# Eliminate Gap Between Active Louver and Front Fascia to Improve A/C Performance

<b>Classification</b>	Repair Bulletin	<b>Section/Group</b>	18 - Thermal Management	<b>Country/Region</b>	All
<b>Year</b>	2016	<b>Model</b>	Model X	<b>Version</b>	All

Figure 1

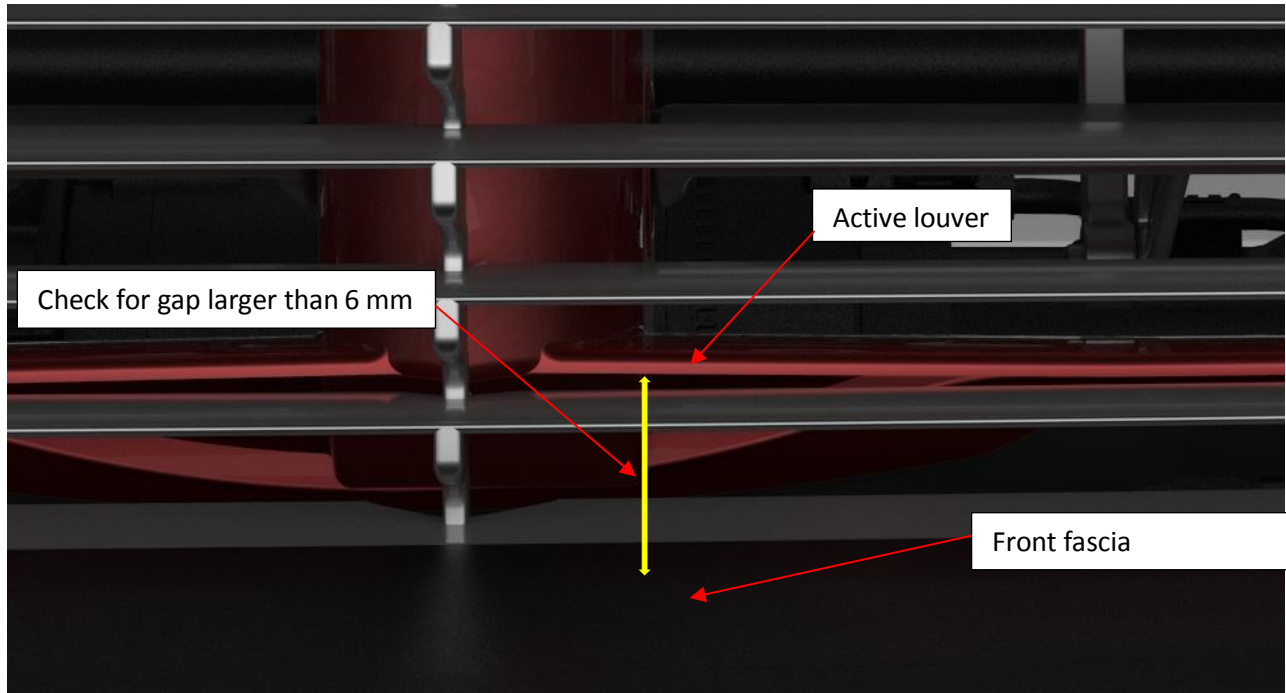
An excessive gap between the active louver and the front fascia might allow hot air to be pulled into the inlet of the A/C condenser, reducing A/C performance in high ambient temperatures.

1. Use a depth gauge to check the gap between the bottom of the active louver housing and the top of the front fascia opening (Figure 1).
  - If the gap is 6 mm or less, a seal is not required. Discontinue this procedure.
  - If the gap is greater than 6 mm, continue to the next step.

If diagnosis determines that there aren't any other potential causes of poor A/C performance, inspect the gap between the active louver and the front fascia, and if necessary, install a seal.
